Monitoring Report

Facility Name: Hyland Landfill

Date: December 31, 2012

Reporting Period: December, 2012

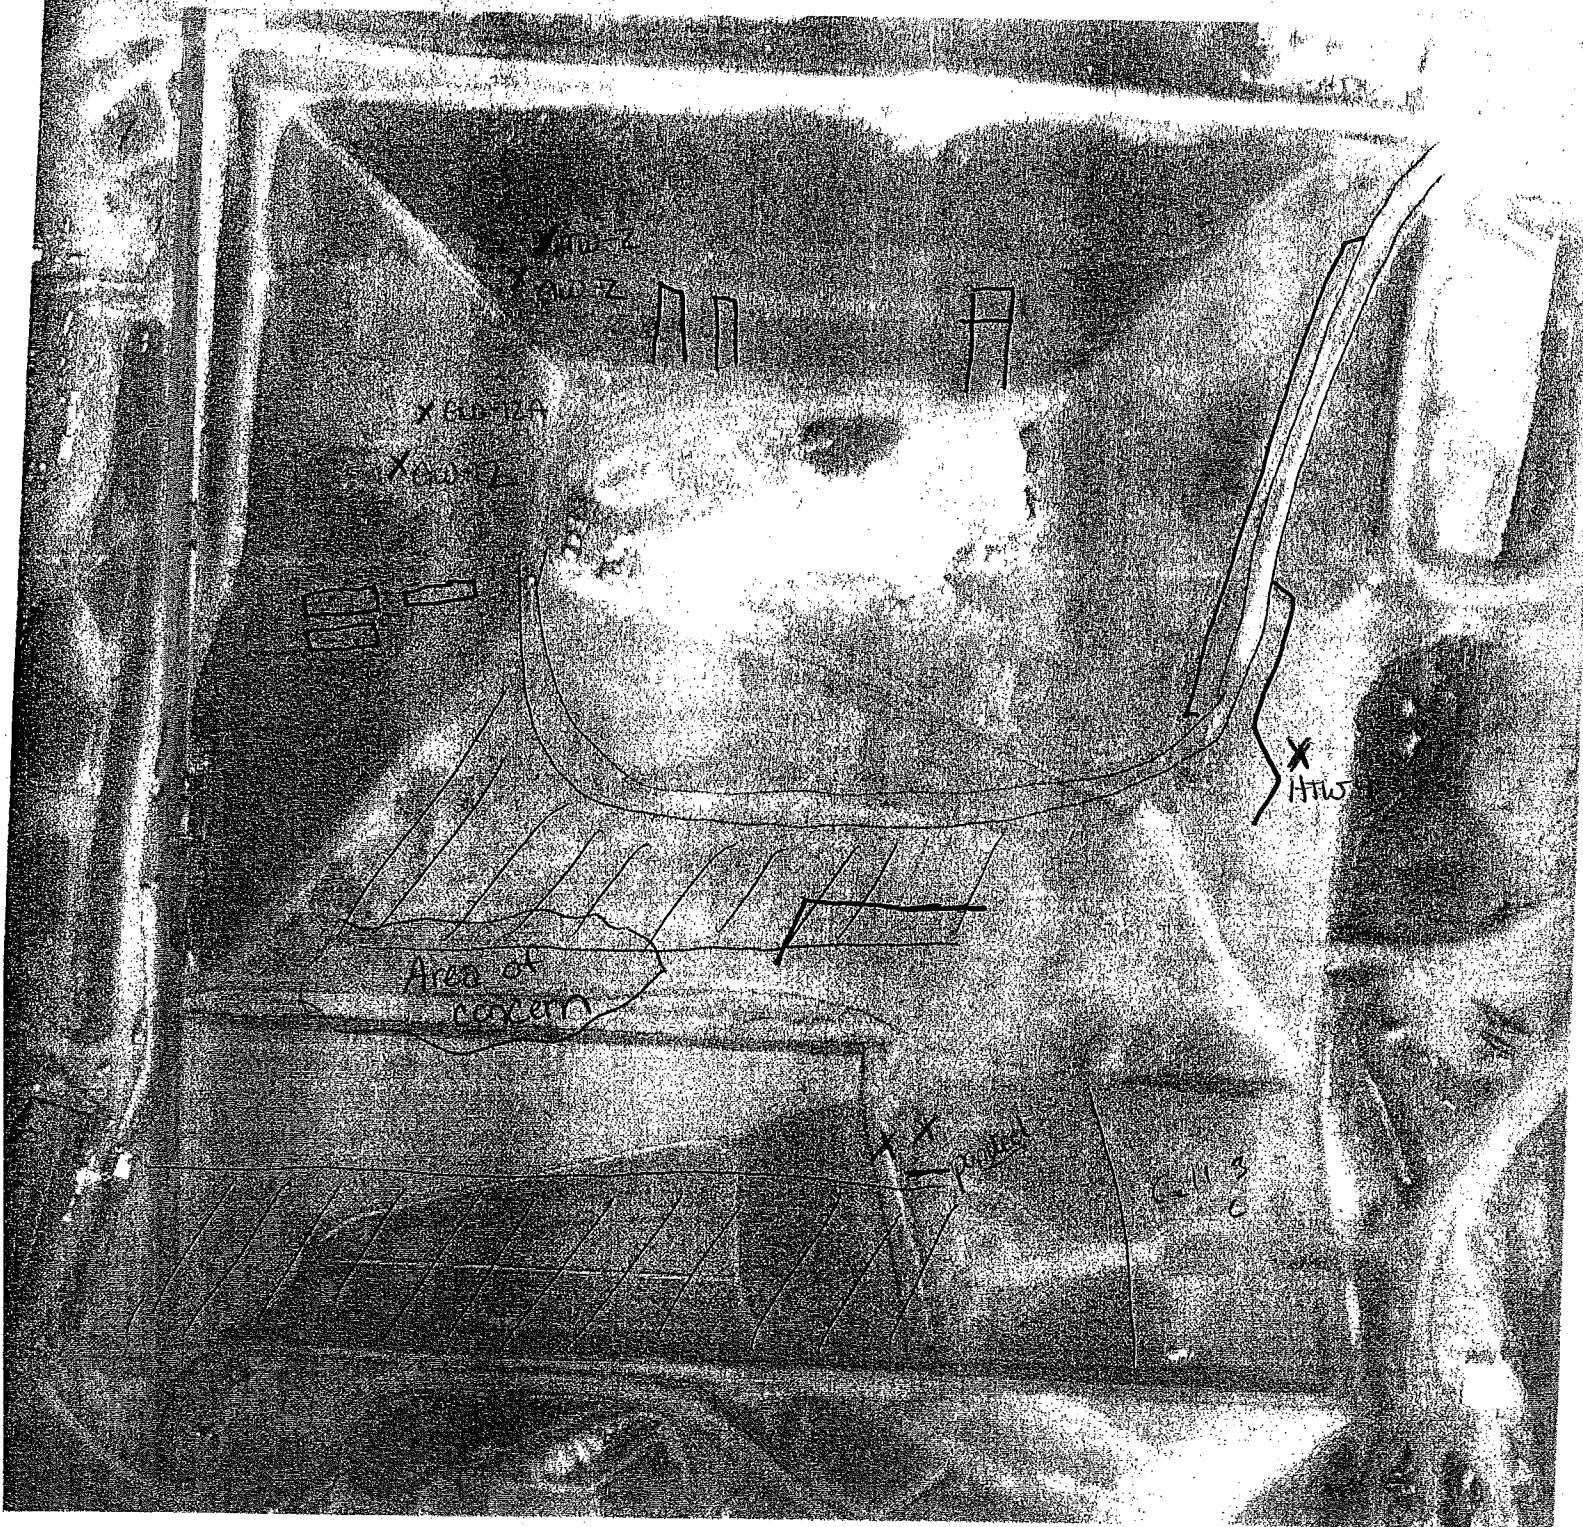
- Breakouts found: (See map)
  - 1 on East slope above HTW 9-2
  - South slope 2 seeps found below horseshoe, some penced suspected areas along road going up into Cells 1+2 and in area above tire crips.
  - 2 on west slope, one below GW12-A and one near GW12
  - North slope right above HTW-2 and right below GW-2

- need to dress up repairs made on north slope above gas line
- Cell 4A, garbage still needs tarping and needs removal of any unacceptable first lift items.
- South slope has areas of exposed garbage that needs more cover

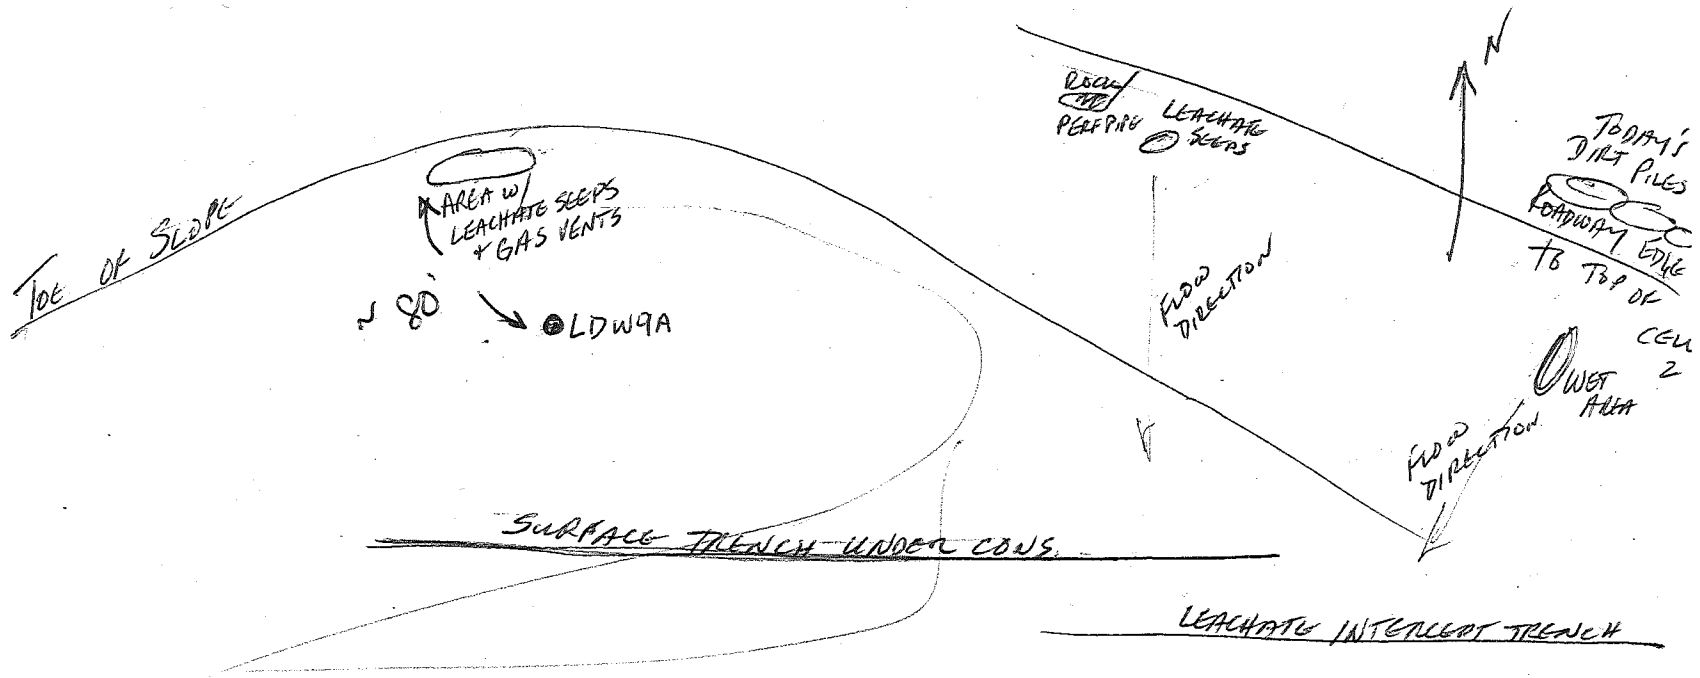
@ landfill - North + West slopes look good. Some <sup>ASR</sup> tracking + litter along haul road - ASR tracking along loop around leachate basins; @ cell 4 <sup>pumps</sup> display panel

leachate sprays from grease fitting on leachate loadout arm

Leachate Problems:

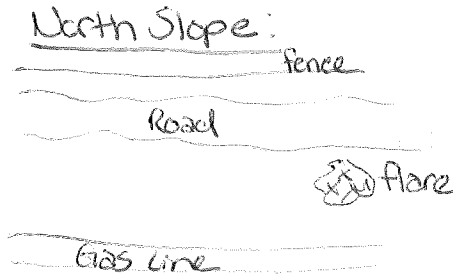
total of 2

total of 2 possibly 3

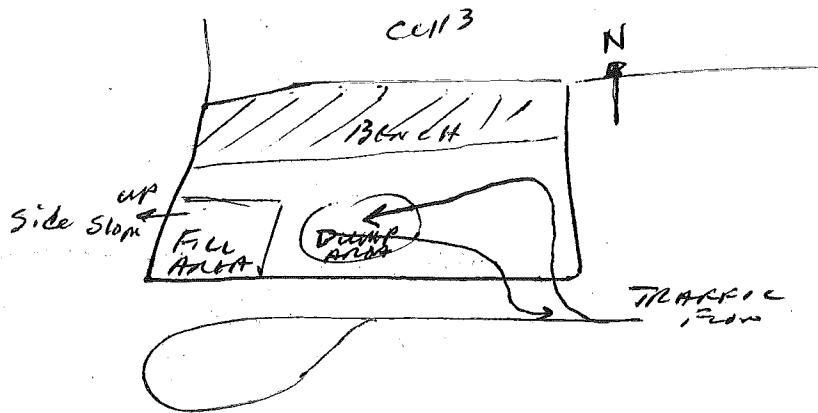
South slope - ① gas line trench still open - exposed waste from excavation.

- ② Gas well w/ ball & duct tape cap is leaking gas
- ③ Wet soil/leachate seep ~50-75' west of stump, 20' N of gas well
- ④ Leachate seeps emerging @ slope - west of stump -
- ⑤ Trench @ base needs to be dug deeper & filled w/ tire chips 1/3
